RE: Data Response, Set 1A
Ivanpah Solar Electric Generating System (07-AFC-5)

Ivanpah Solar Electric Generating System (ISEGS)

Data Response, Set 1A

(Response to Data Requests 1 through 116)

FIGURE DR4-1
AREA FOR ADDITIONAL HELIOSTATS
IVANPAH SOLAR ELECTRIC GENERATING SYSTEM

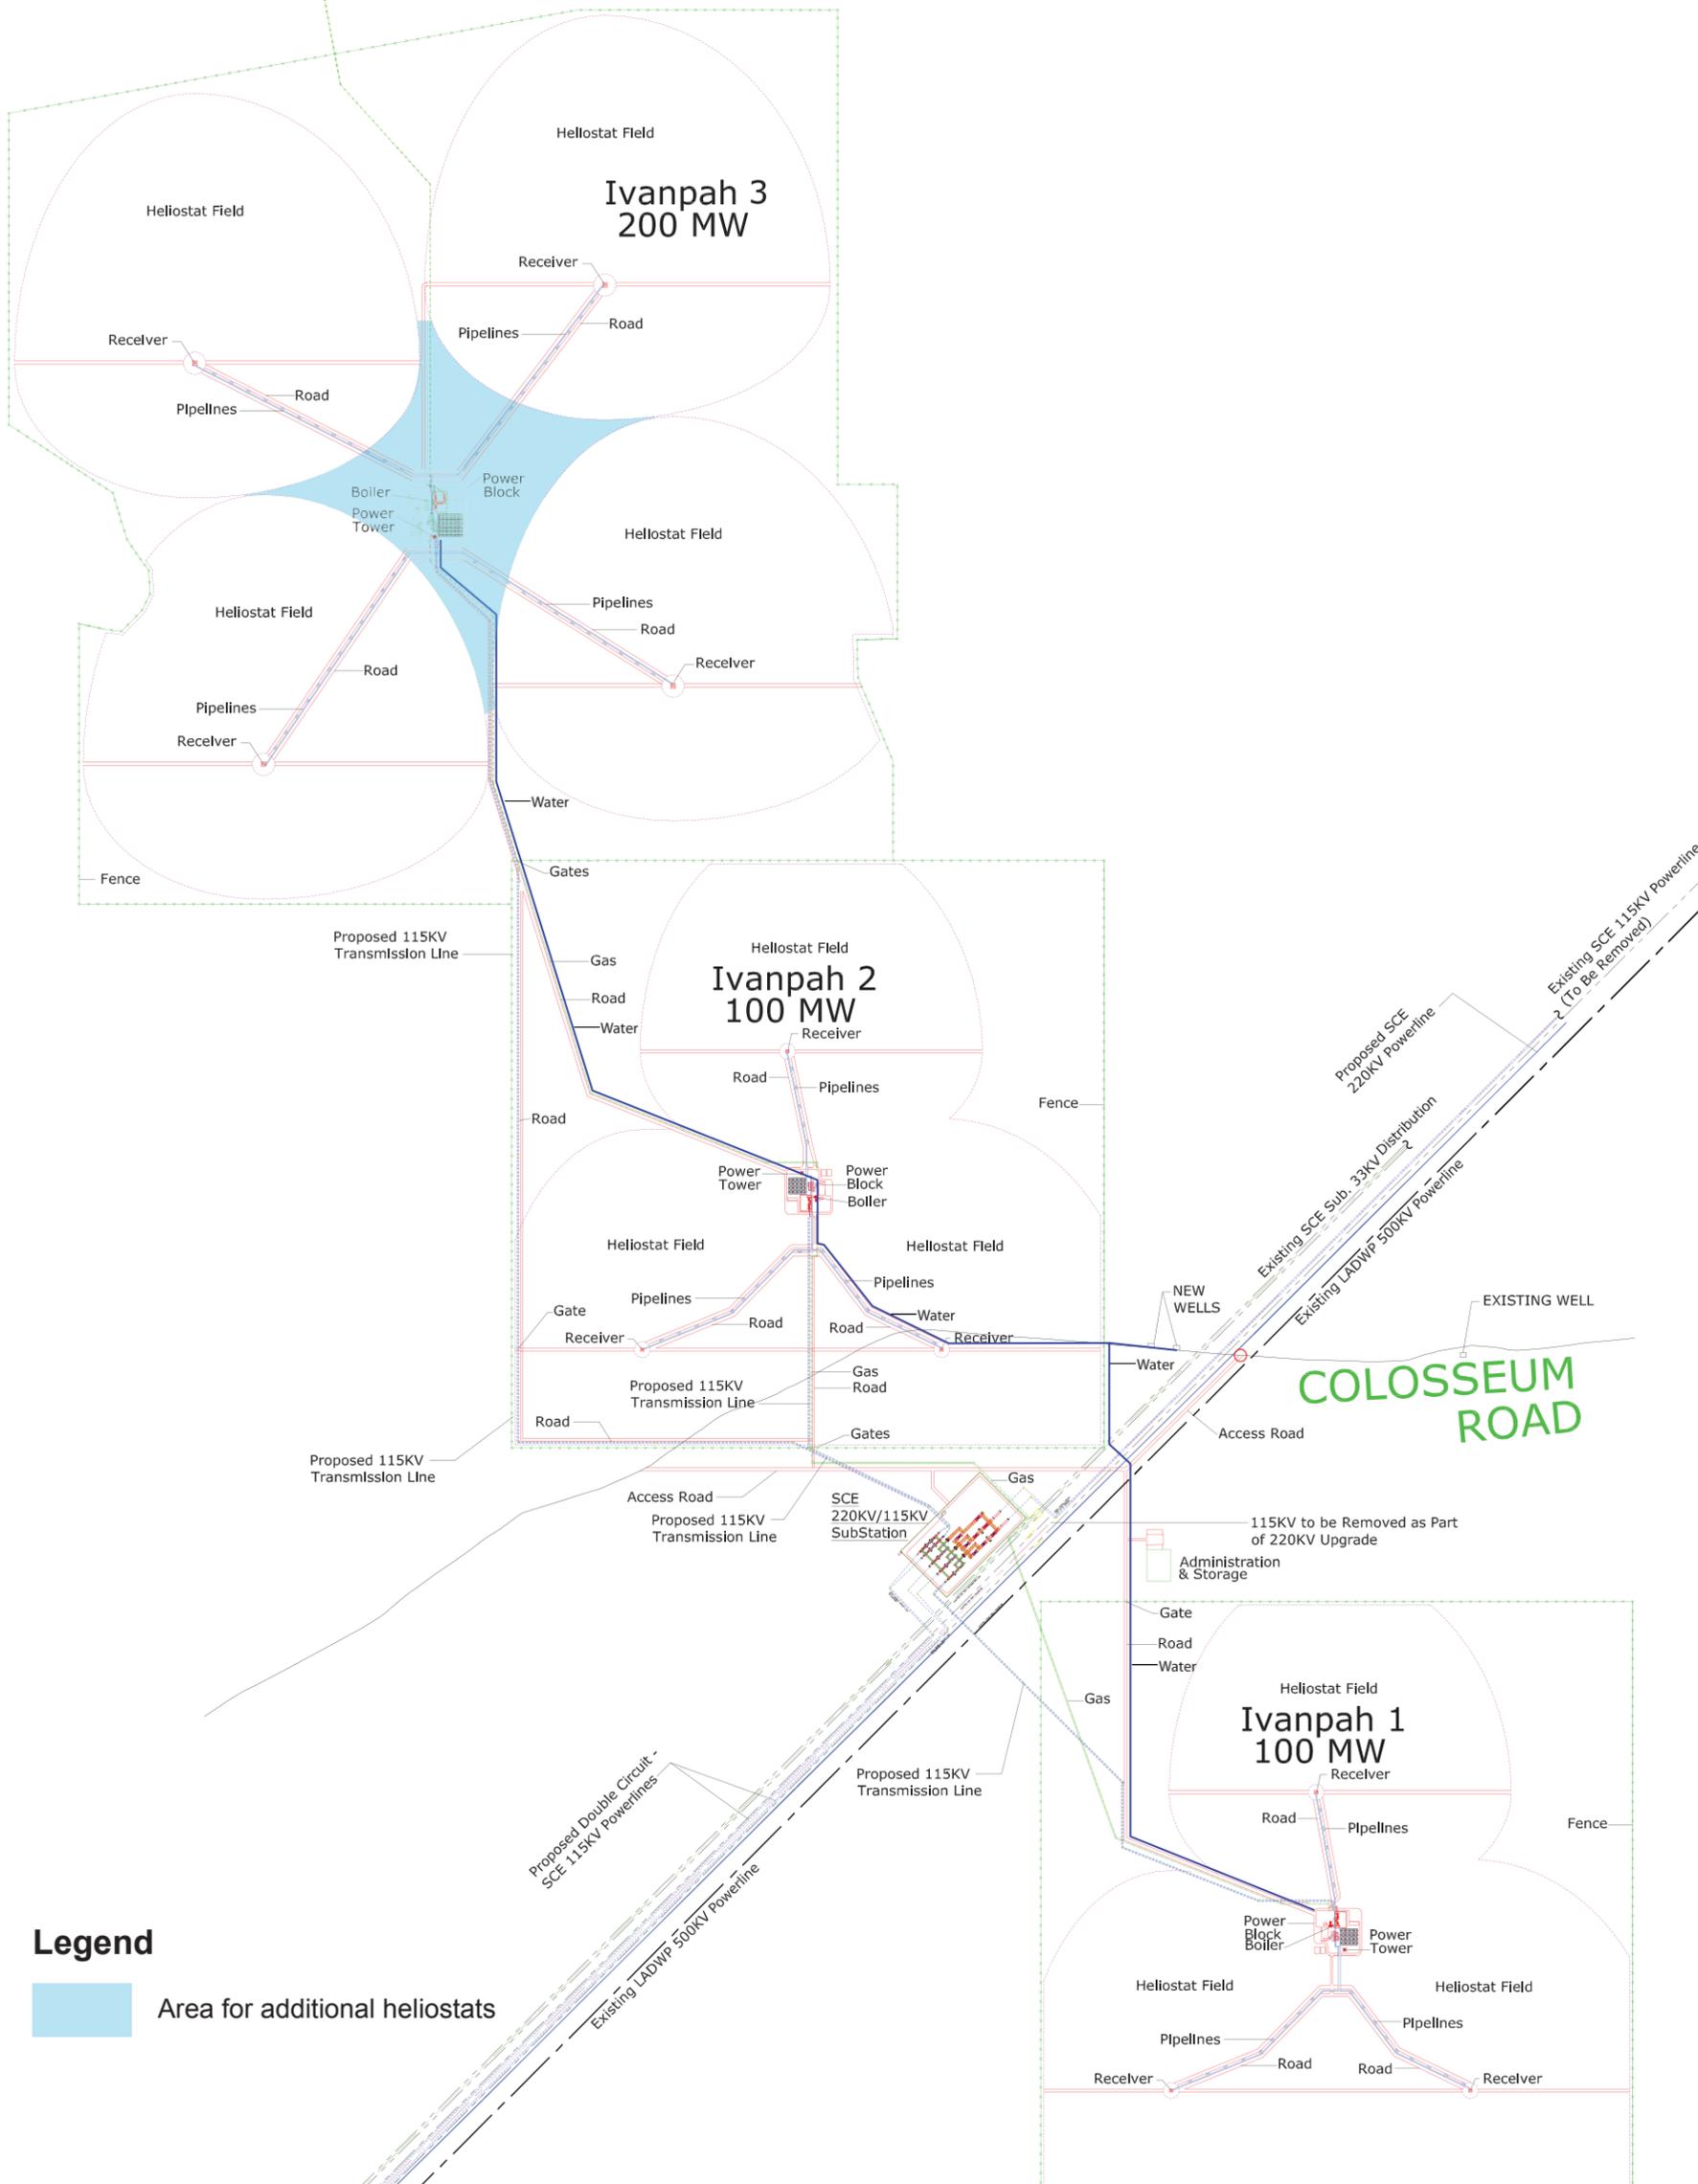
Plan of Development, 2.2 Process Description cites "Additional heliostats would be located outside the power block perimeter road, focusing on the reheat tower. Their

Response: The statement refers only to the Ivanpah 3 plant of 200MW, the intention being to install additional heliostats inside the area formed between the four solar fields, as shown on the attached drawing Figure DR4-1. This area (excluding the power block) is approximately 101.2 acres and is included as part of the project’s 3,400-acre total.

FIGURE DR80-1b
IVANPAH 2
MAJOR HYDROLOGIC FEATURES
IN AND NEAR THE PROJECT SITE
 IVANPAH SOLAR ELECTRIC GENERATING SYSTEM

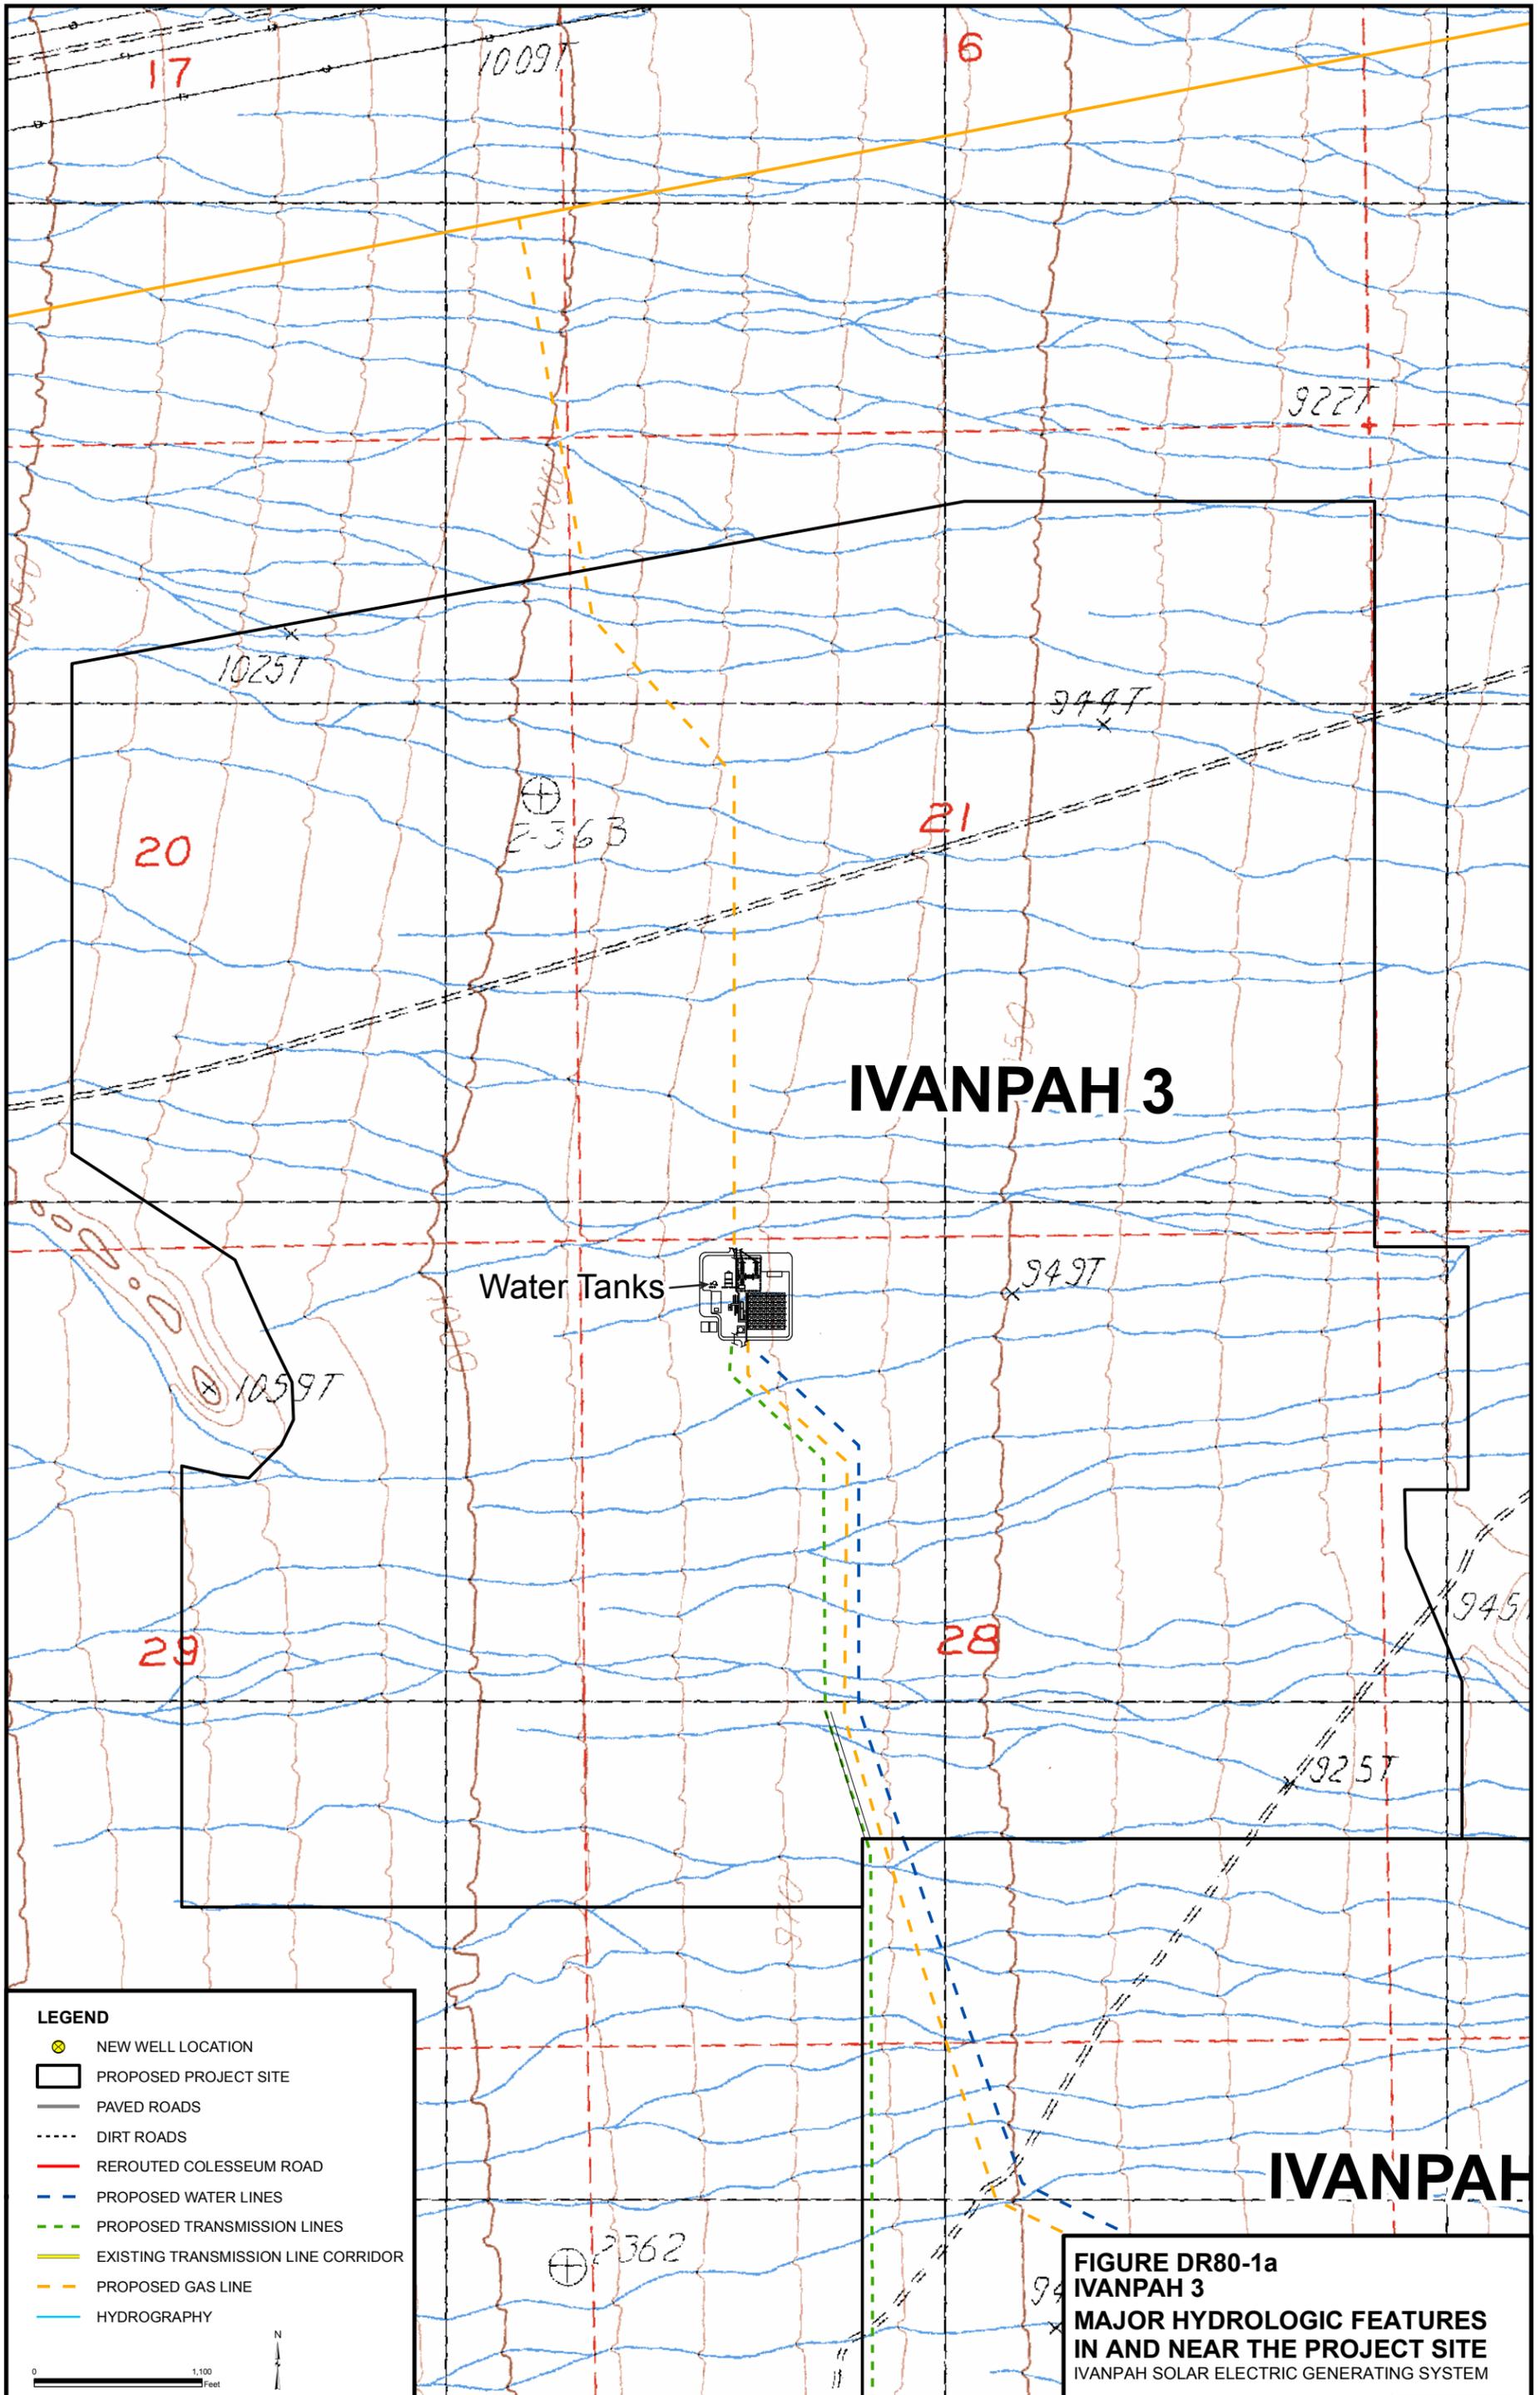
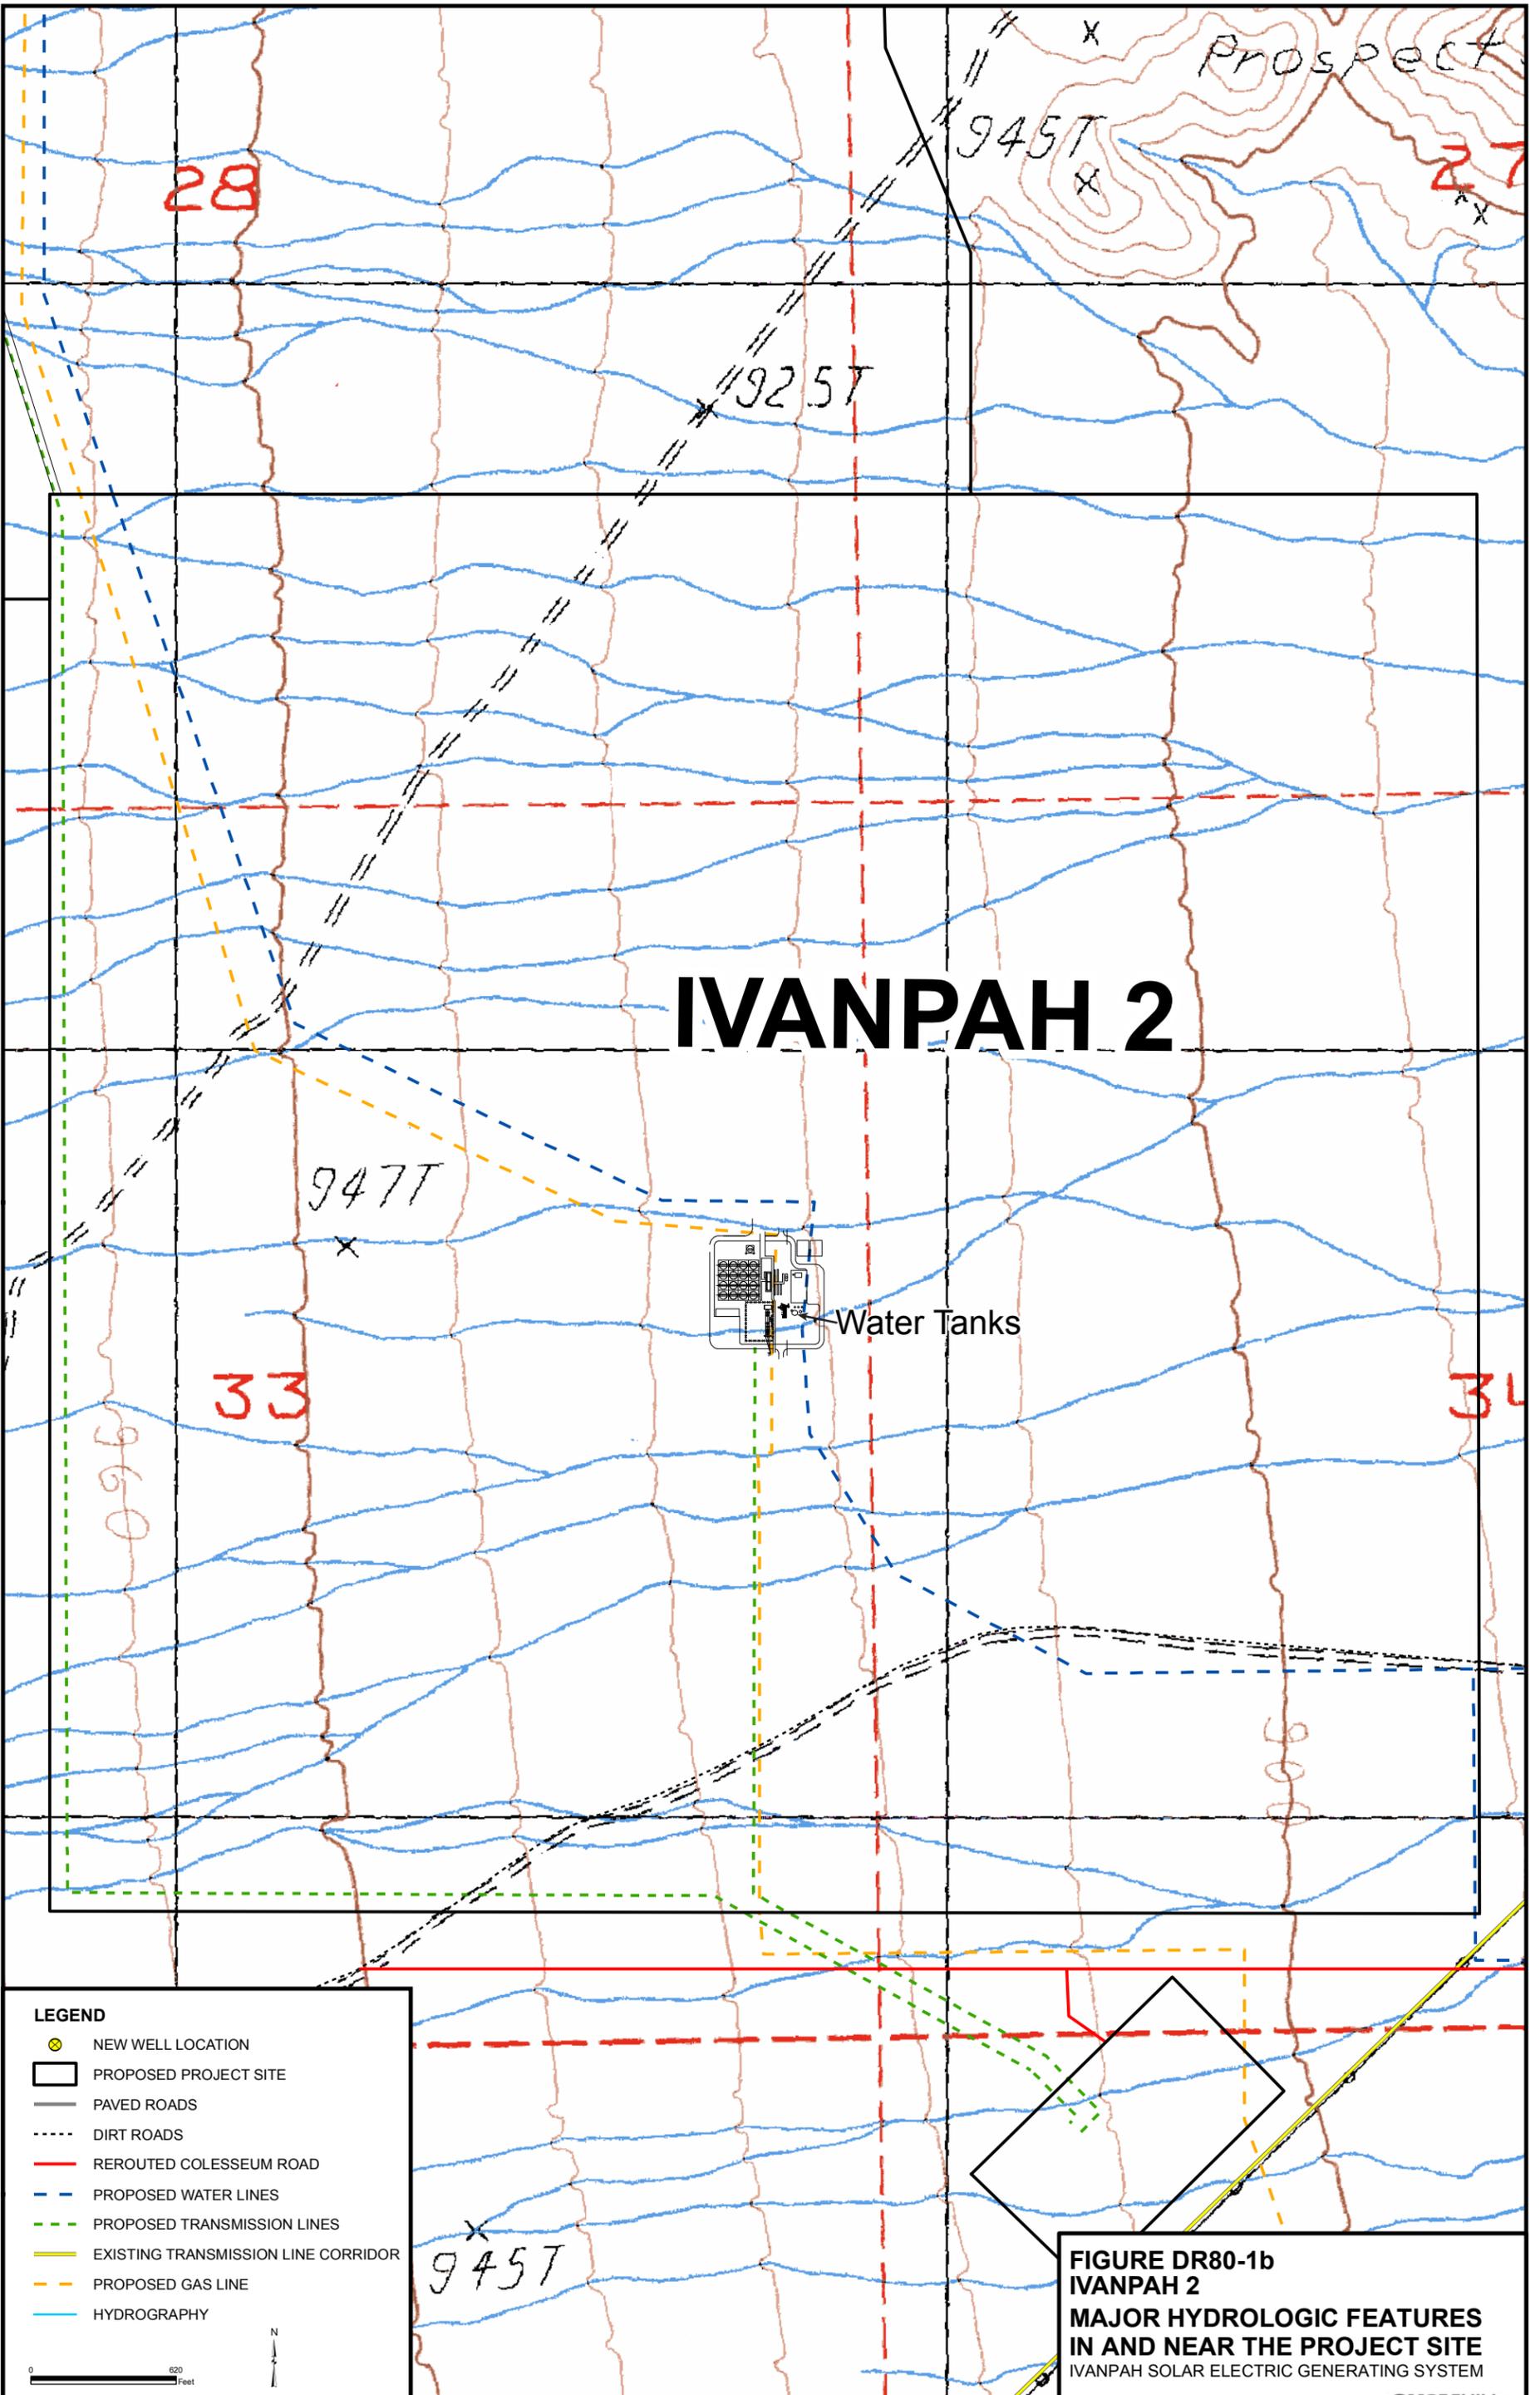
80. Please show the location of the proposed water tanks and distribution lines on a revised Figure 5.15-2 (Major Hydrologic Features In and Near the Project Site).

Response: The scale of AFC Figure 5.15-2 has been revised to allow the power block to be shown. Each phase is shown in a separate figure. Figure DR80-1a is Ivanpah 3, Figure DR80-1b is Ivanpah 2, and Figure DR80-1c is Ivanpah 1. The location of the water tanks is indicated on each figure.
